We appreciate Dr. Zhao for the careful review of our paper and the constructive comments.

Reply to the specific comments

Fig. 1 Plasticity Chart

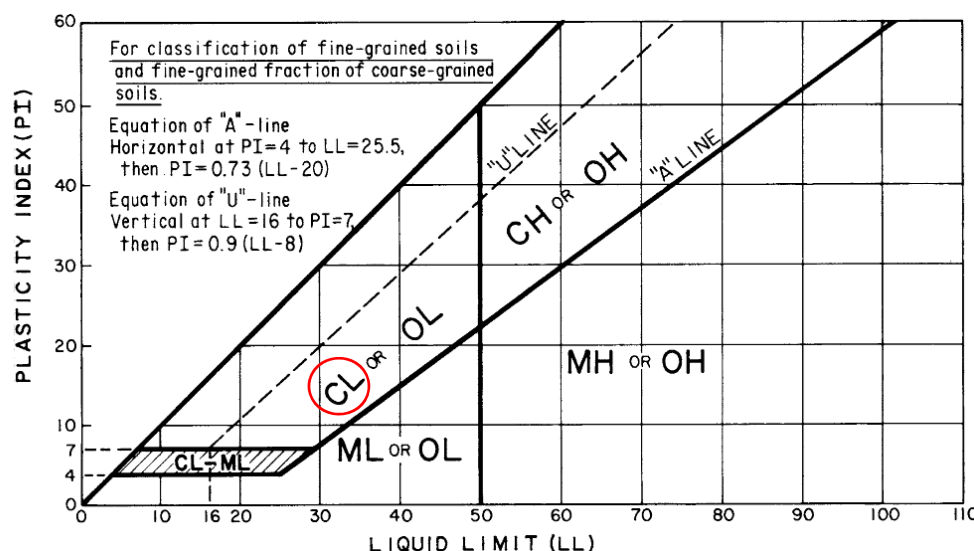
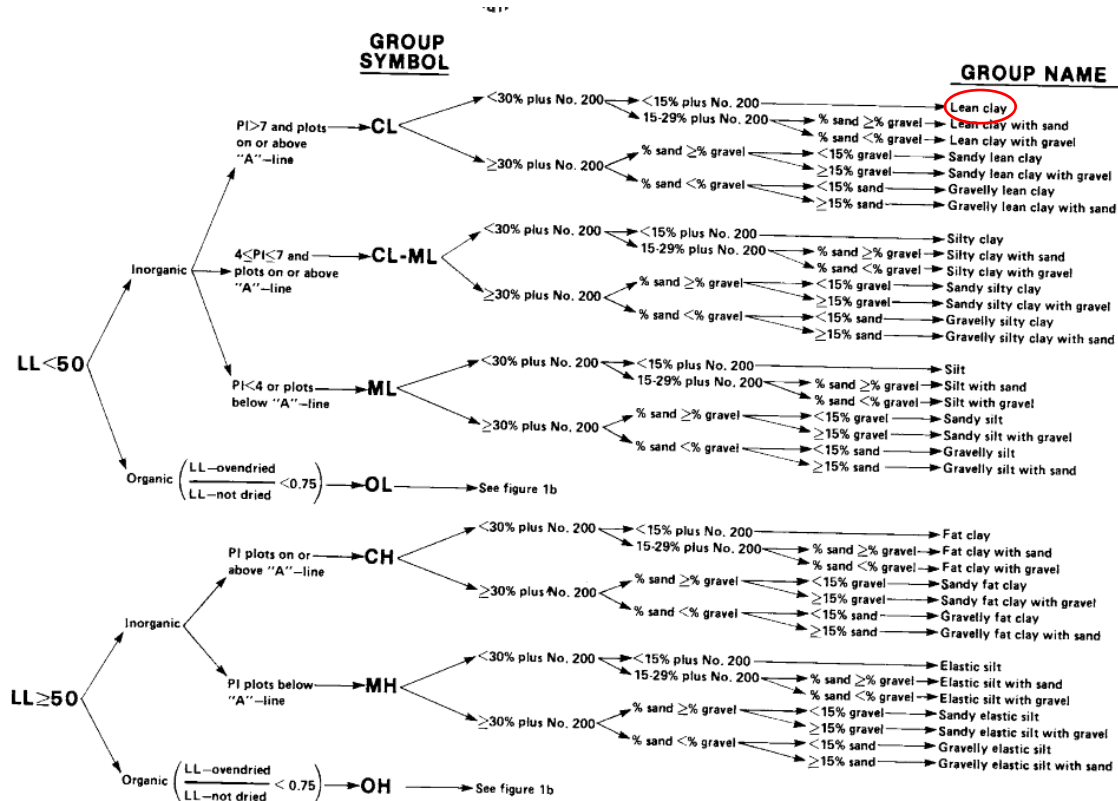
5. In Line 80, can you give a reference to the classification of “silt clay”?

Re: Thank you for your carefulness. There is a mistake here. The term “silt clay” should be “silty clay”. The term “silty clay” comes from Code for design of building foundation of China (GB50007-2002). In the code, the cohesive soils are defined as soils with the plastic index larger than 10. Cohesive soils can be classified into clay and silty clay. If the plastic index is larger than 10 and less than 17, the soil is defined as silty clay and clay otherwise. The plastic index of the soil used here is 10.5, so it belongs to silty clay according to this criteria.

But the soil used in the experiments are not called “silty clay” according to the unified soil classification system (USCS). Instead, it is classified as clay with low plasticity (CL) according to Fig. 1. More specifically, it is named as “lean clay” according to Fig. 2. For better communication, “silty clay” in this paper is modified into “lean clay”.

Fig. 3 Experiments layout

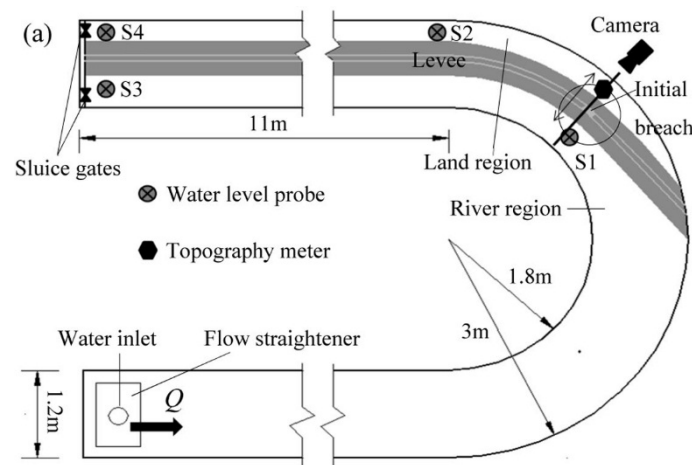
7. In Line 199, please give the reasons of choosing numerical model. In practice, the measurement should be chosen in the breaching test.

Re: In the experiments for overtopping breaching of embankment, the breach discharge are hardly to measure directly because of the unsteady characteristics of the breaching flow. There are no equipment that is suitable to measure real-time breach discharge in open channels. Although the weirs can be used to measure discharge, it is not proper to place it just at the embankment toe. And it is unable to measure the discharge when water level is lower than the weir height.

Generally, indirect methods are usually used to evaluate the breach discharge. There are two common methods. The first one is the method by broad-crested weir formula, in which the

embankment breach is assumed as a broad-crested weir. The other one is the method of water volume balance. And the second method utilizes the balance of either the reservoir water or the downstream water. When using the balance of the reservoir method, the breach discharge equals inflow discharge minus reservoir volume variation per unit time. While when the balance of downstream water is utilized, the breach discharge equals the outflow discharge plus downstream water volume variation per unit time.

In the experiments described in this paper, the morphology of the breach is irregular and the surface of the breach is not smooth. It is difficult to confirm accurate discharge coefficient. So the breach discharge could not be evaluated by broad-crested weir formula. On the other hand, the method of water volume balance is also not suitable. In the river region, except for the inflow discharge and breach discharge, there also exist the flow out from the sluice gate, which is not easily measured because it is mixed with the flow out of the sluice gate in the land region. And because the channel is too long, it is hard to evaluate the water volume change accurately. Similarly, evaluating the breach discharge by water volume balance method in the land region is also not viable.

Fig. 4 Numerical results for wet bed

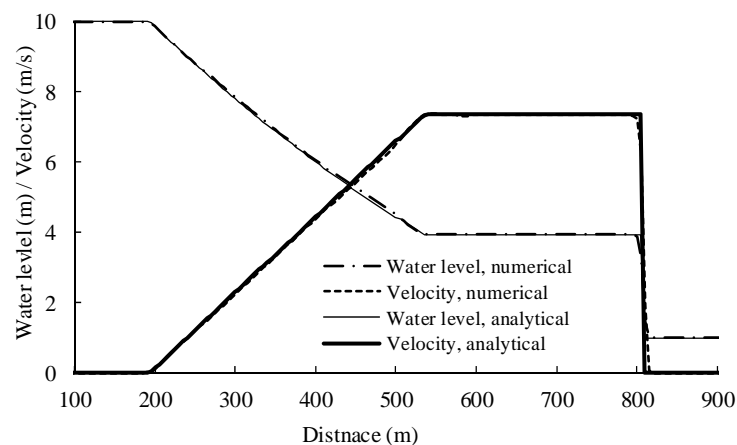
8. In line 199, you proposed to use a 2D flow model. Can you give a reference of this model? Has the model been validated to apply in the breaching flow? Does the model a non-hydrostatic module or a hydrostatic module?

Re: The depth-averaged 2-D flow model used here is based on the assumption of hydrostatic pressure. The 2D flow model proposed in this paper has been used by Dou et al. (2014) to simulate non-cohesive levee breach in the same flume. In this model, the numerical fluxes were calculated by WENO–Roe method based on Riemman solvers that can capture flow discontinuity. This ensure the model suitable for dam break simulation, which has been validated in these following examples.

Consider a rectangular area 1200 m long and 100 m wide with flat and smooth bottom. The dam location is 500 m from the upstream. The initial water depth in the reservoir is 10 m. To verify that the model can simulate dam break flow in both wet and dry bed, the water depth in the downstream of the dam is set as 1 m and 0.001m, respectively. Transient dam break is considered. Grid size of 5 m is selected.

Calculating water level and flow velocity after 30 s for wet bed are shown in Fig. 4. It can be seen that the calculated results match well with the analytical solutions and are without obvious
